Appendix A

Notice of Preparation and Scoping Comments

Notice of Preparation of an Environmental Impact Report and Public Scoping Meeting Notice

RE: Laguna Creek Diversion Retrofit Project

Proposed Facility Improvements (Cross-section)

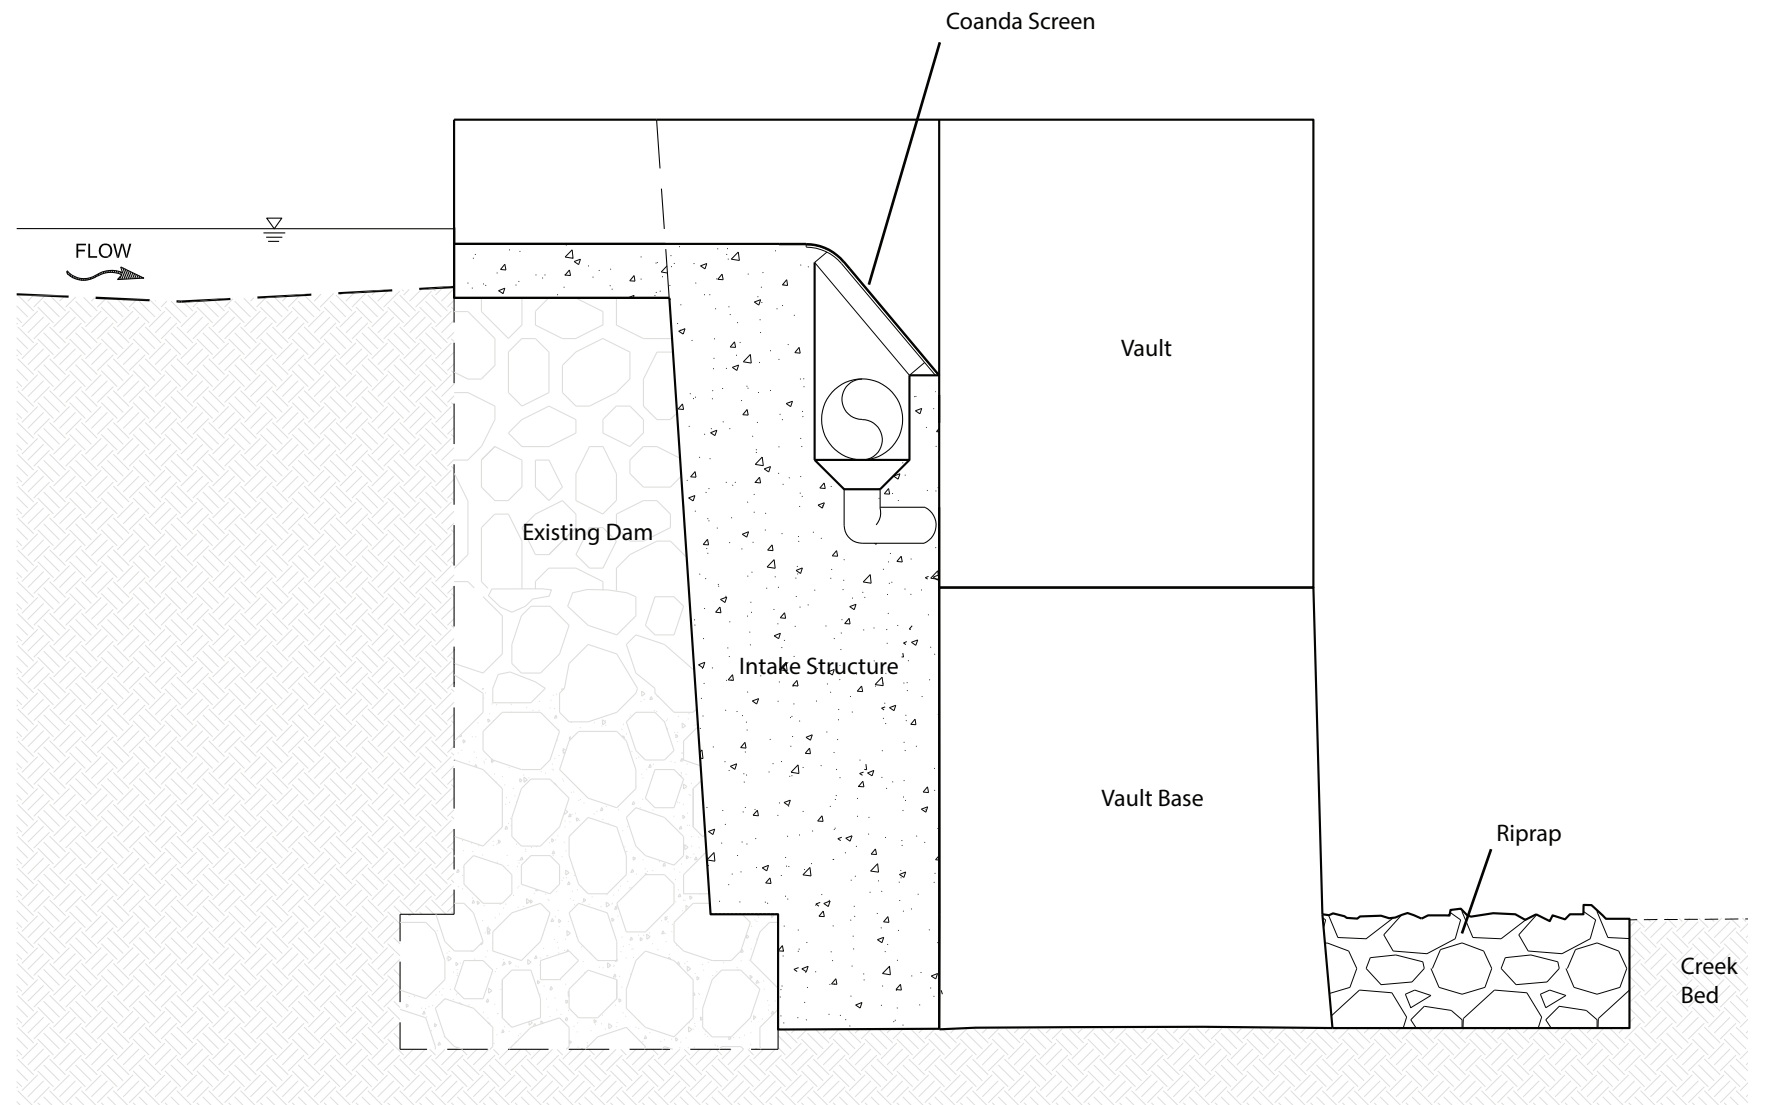
- Detailed descriptions and cross sections of armored streambank and apron; and
- Operation and maintenance of the new system, including but not limited to, timing of sediment releases.
